ABS T4 Feedback

Model Name: BFX-AT100

Document Version: ALT_STB_MP_CSMTINS_001

Issued Date: 2023.01.17

T4 – Top view

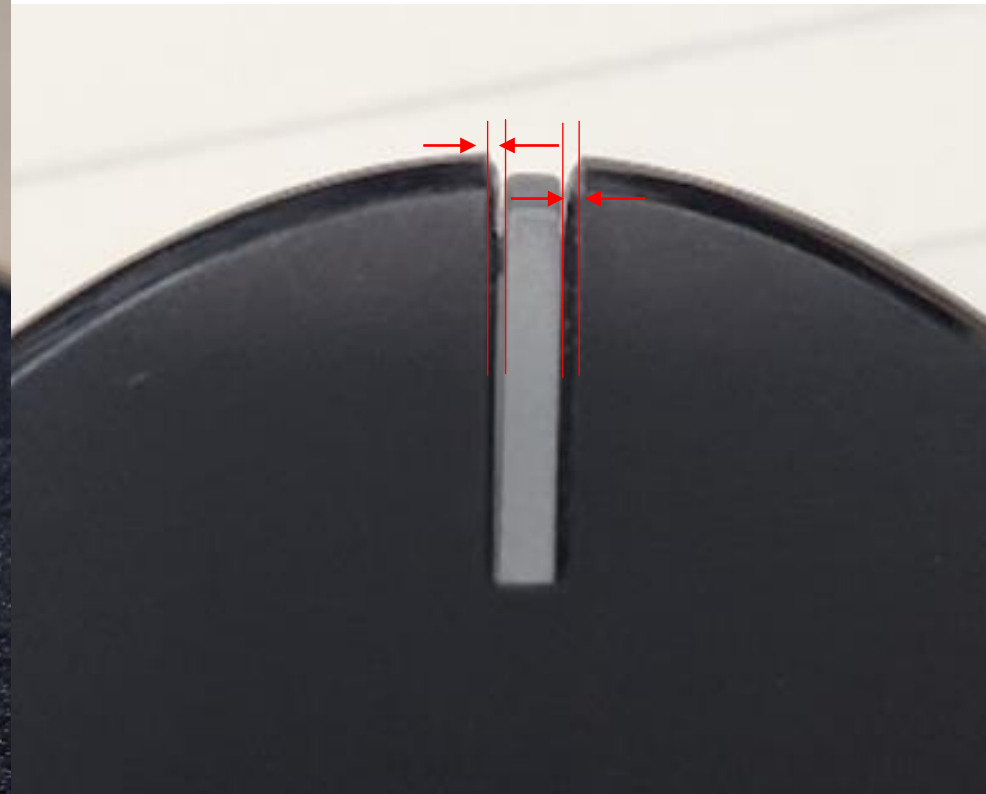
- Large gap between LED leans and Top case
 - It is same gap as T4 and T3
 - ALT is suggest that increase the light pipe size

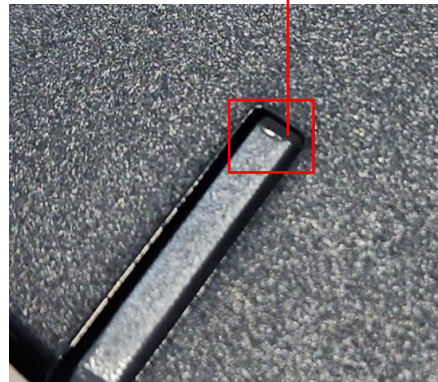
- Need to improve gas mark
 - T4 condition is not good

Injection date code

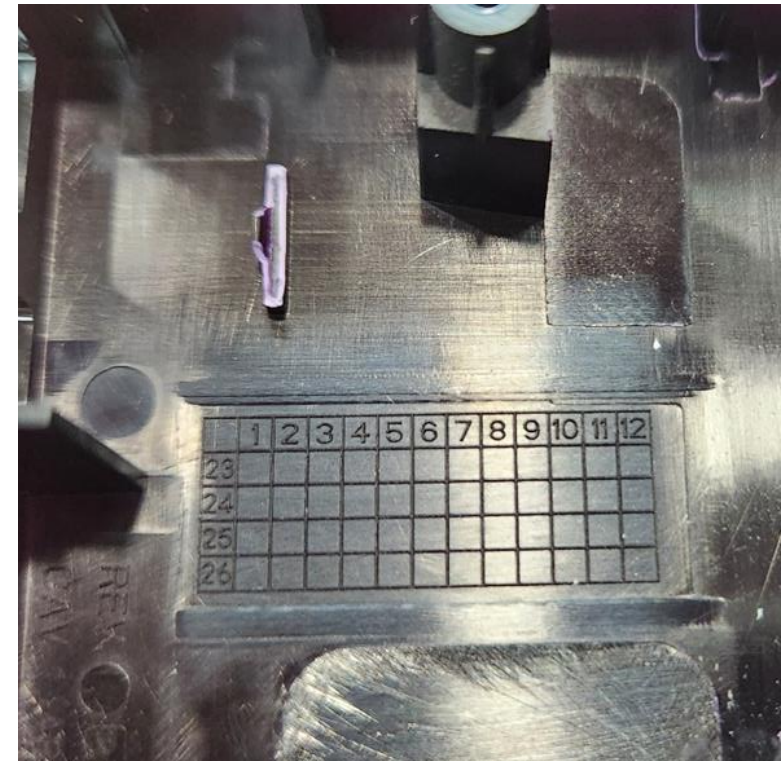
- Please update each injection date
